<b>ENGINEERING CHANGE PROPOSAL (SHORT FORM)</b> (See MIL-STD-481 for instructions)				DATE (YYYYMMDD) 20040201		Form Approved OMB No. 0704-0188	
				<b>PROCURING ACTIVITY NUMBER</b> N/A			
The public burden for this collection of information is estimated to average 2 hours per response, including the time for reviewing instructions, searching existing data sources, gathering and maintaining the data needed, and completing and reviewing the collection of information. Send comments regarding this burden estimate or any other aspect of this collection of information, including suggestions for reducing the burden, to Department of Defense, Washington Headquarters Services, Directorate for Information Operations and Reports (0704-0188), 1215 Jefferson Davis Highway, Suite 1204, Arlington, VA 22202-4302. Respondents should be aware that notwithstanding any other provision of law, no person shall be subject to any penalty for failing to comply with a collection of information if it does not display a currently valid OMB control number. <b>PLEASE DO NOT RETURN YOUR FORM TO THIS ADDRESS.</b>

<b>1. ORIGINATOR NAME AND ADDRESS</b> Lance Delahaye Software Engineer Osmar Intl NZ				<b>2. CONTR

Figure 1

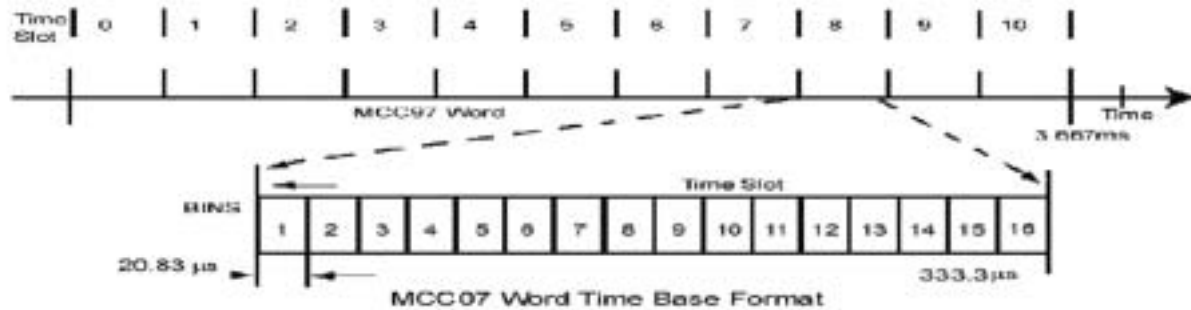
<b>16. NEED FOR CHANGE</b> The bin numbering is incorrect and needs to be changed to reflect the proper bin numbering or designers building MILES equipment will not be able to work with existing MILES equipment.							
<b>17. EFFECT ON ASSOCIATED EQUIPMENT</b> If proposed documentation change is not made new MILES equipment will not work with older MILES equipment.							
<b>18. PRODUCTION EFFECTIVITY BY SERIAL NUMBER</b>				<b>19. EFFECT ON PRODUCTION DELIVERY SCHEDULE</b>			
<b>20. RECOMMENDED RETROFIT EFFECTIVITY</b>				<b>21. ESTIMATED KIT DELIVERY SCHEDULE</b>		<b>22. ESTIMATED COST/SAVINGS</b>	
<b>23. SUBMITTING ACTIVITY AUTHORIZING SIGNATURE</b>				<b>23.a. TITLE</b>			
<b>24. APPROVAL/DISAPPROVAL</b>

The Word time base clock rate is 48KHz  $\pm$  0.015%. The word time base is partitioned into 11 Time Slots labeled 0, 1, 2, ... 10. The Time Slot duration is 333.3  $\mu$ s  $\pm$  0.015% based on the on the 3KHz sub-harmonic of the 48KHz time base clock. Each Time Slot is further subdivided into 16 time intervals; each referred to as a Bin. The Bins are numbered by convention 1, ... 16. Each Bin has time duration of 20.83  $\mu$ s  $\pm$  0.015% based on the fundamental 48KHz-clock frequency. The Word has a total duration of 3.667 ms  $\pm$  0.015%. Refer to Figure 1(below).

The Word time base clock rate is 48KHz  $\pm 0.015\%$ . The word time base is partitioned into 11 Time Slots labeled 0, 1, 2, ... 10. The Time Slot duration is 333.3  $\mu\text{s}$   $\pm 0.015\%$  based on the on the 3KHz sub-harmonic of the 48KHz time base clock. Each Time Slot is further subdivided into 16 time intervals; each referred to as a Bin. The Bins are numbered by convention 0, 1, ... 15. Each Bin has time duration of 20.83  $\mu\text{s}$   $\pm 0.015\%$  based on the fundamental 48KHz-clock frequency. The Word has a total duration of 3.667 ms  $\pm 0.015\%$ . Refer to Figure 1(below).

**Figure 1: MCC Word Time Base Format****3.2.1.2.2. Bit Positioning.**

**Figure 2: MCC Word 12.1.A.211 Bit Pattern**

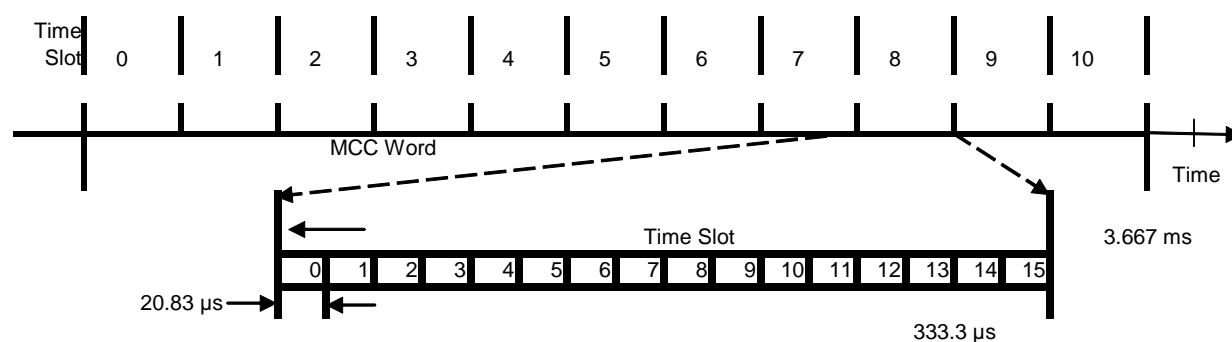
For example, the bit pattern for Word, 12.1A.211, illustrated in Figure 2, translates as follows:

- a. The first two digits, 12, is **X**, the Basic Miles Code bit pattern. Look this up in Appendix A under the entry **X = 12**. Each Logic State 1 is positioned in Bin 1 of the Time Slot corresponding to its column position in Appendix A. A Logic State 1 in column D0 is positioned in Bin 1 of Word Time Slot 0, etc.

3.2.1.3.1 For example, the bit pattern for Word, 12.1A.211, illustrated in Figure 2, translates as follows:

- a. The first two digits, 12, is **X**, the Basic Miles Code bit pattern. Look this up in Appendix A under the entry **X = 12**. Each Logic State 1 is positioned in Bin 0 of the Time Slot corresponding to its column position in Appendix A. A Logic State 1 in column D0 is positioned in Bin 0 of Word Time Slot 0, etc.
